# Colerain Township Board of Trustees

Project: Zone Map Amendment

Case No.: ZA2012-01 Joseph Toyota Inventory Lot

Action Requested: Zone Amendment from R-5, Suburban-High Residential District, to PD-B, Planned District Business, to allow for an expansion of Joseph Toyota.

### CONDITIONS:

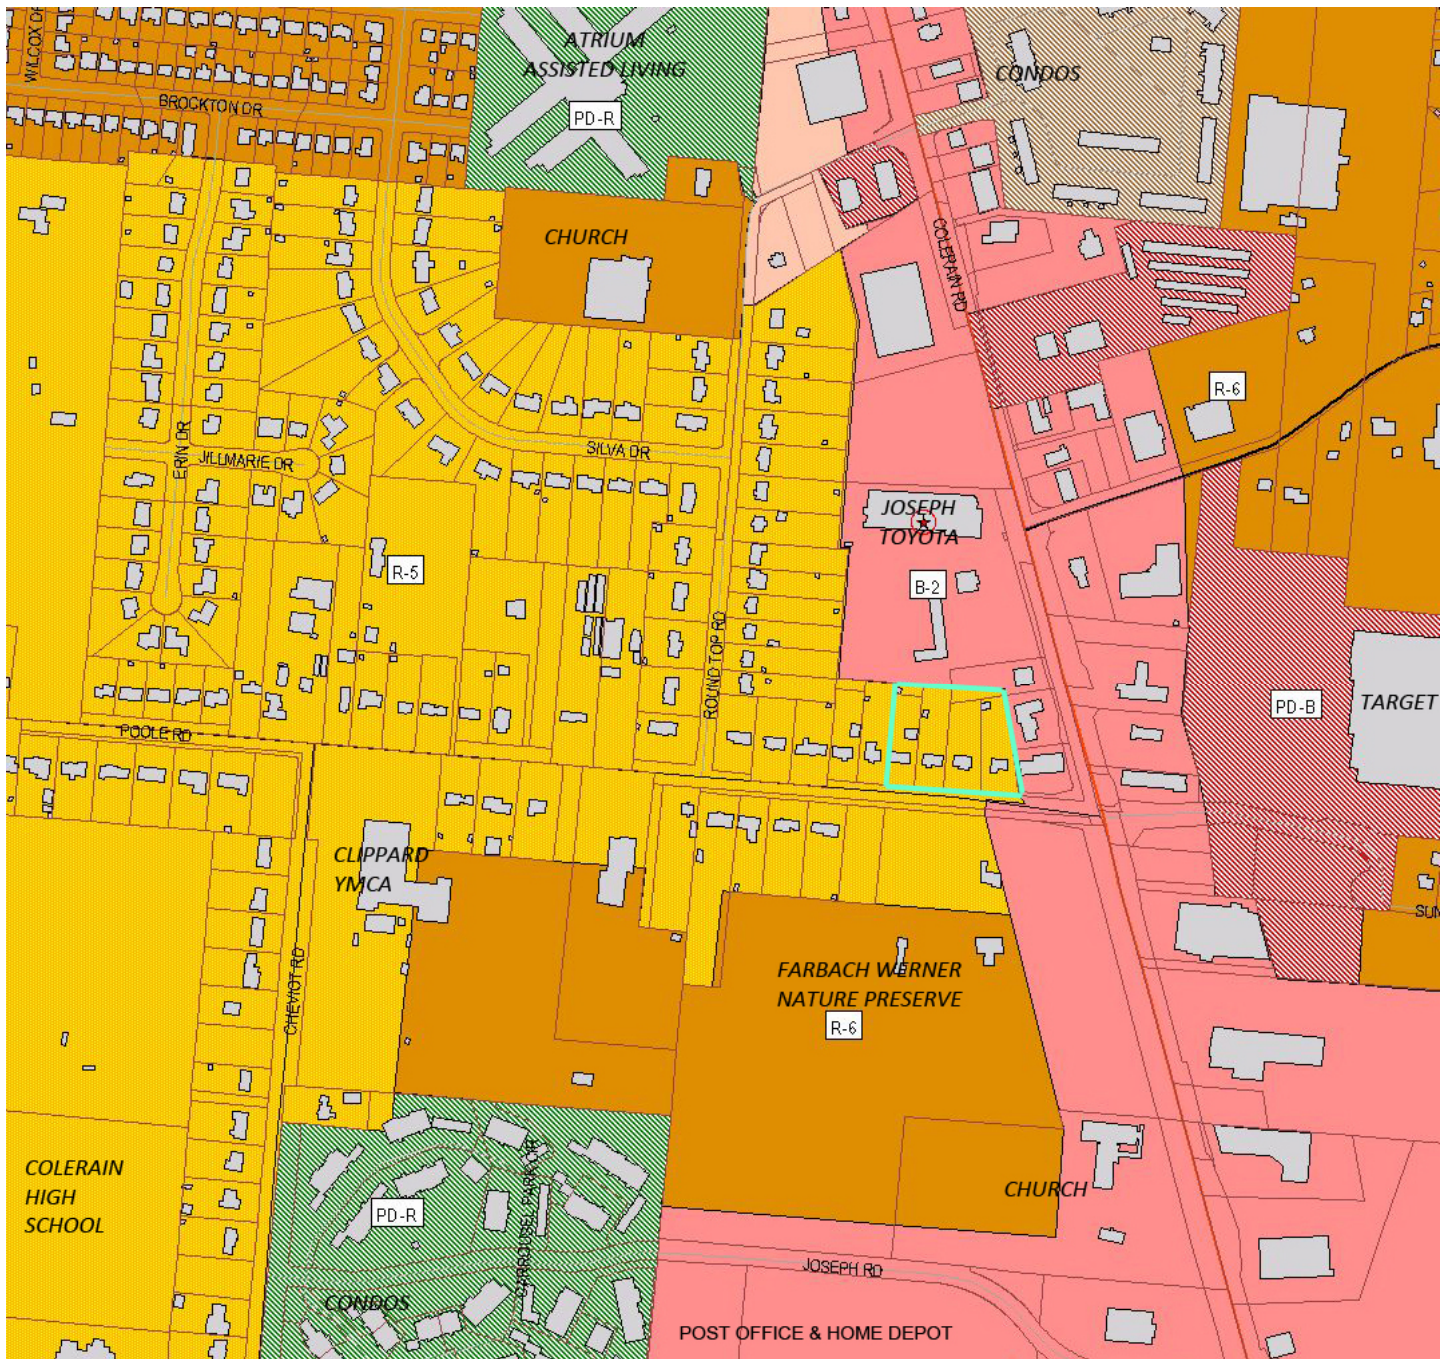
- ☐ The proposed 8-foot vinyl coated chain link fence along the south property line (Poole Rd.) should be replaced with decorative fencing given that Poole Rd. is primarily residential and the fencing would be across from the Farbach-Werner Nature Preserve, which utilizes a 3-4 foot wood post fence.

- ☐ There is a concern that the proposed driveway along Poole Rd. could be used for semi-tractor trailer shipment of vehicles or other dealership traffic and would create a conflict with primarily residential traffic and users of the Nature Preserve on two-lane Poole Rd. If the driveway is approved, it should be sited as far away as possible from the existing residences to the west and should not line up with the Nature Preserve entrance as they are incompatible uses.

- ☐ Please clarify if the rezone area includes the entire parcel with the house to remain—parcel 128. A zoning plat and legal description has not been provided so it is unclear what the parameters of the zone change are. The dimensions shown on the plan do not go to the centerline of Poole Rd. and do not include parcel 128 (3434 Poole Rd.), so it is not clear if these areas are part of the zone change, though 3434 Poole Rd. is part of the application.

While the proposed amendment to a business zoning district is accounted for in the Land Use Plan, there are two specific elements that are not in accordance: 1.) Only a 30-50 foot buffer (rather than 75-feet) is allotted for along the western property edge, and 2.) Outdoor storage is highlighted in the reasoning as a prohibited use.

20% open space is required in a Planned District Business zone. Given the need for a buffer on the western property line, a significant amount of greenspace is provided there, roughly 12%. The land area of the property located at 3434 Poole which will remain a residence, is included in the zone change but it is neither included in the impervious surface nor overall calculations. The addition of that land would greatly increase the open space area.

1. Parcels 0510-0104-0129 thru 0133 shall be consolidated with parcel 0510-0104-0121 (the primary Joseph Toyota parcel);
2. There shall be no curb cut onto Poole Road;

3. There shall be no additional signage;
4. The lot shall be for automobile storage only (no step-vans, trucks, recreational vehicles, commercial vehicles, etc.);

5. Light poles shall be a maximum height of 12 feet, 0.1 footcandles maximum at grade, with fixtures shielded to the south and west;
6. The revised landscape plan shall be reviewed and approved by the Landscape Advisory Board;

7. Landscaping shall be installed and approved prior to occupancy of the site;
8. The landscaping shall be irrigated;
9. There shall be a 75-foot buffer to the west;

10. Existing trees (excluding those diseased or dead) in the west buffer shall be maintained;
11. Split rail or shadow-box fence shall be used to the west, south, and east; chain link fencing shall be permitted only on the north side of the lot;
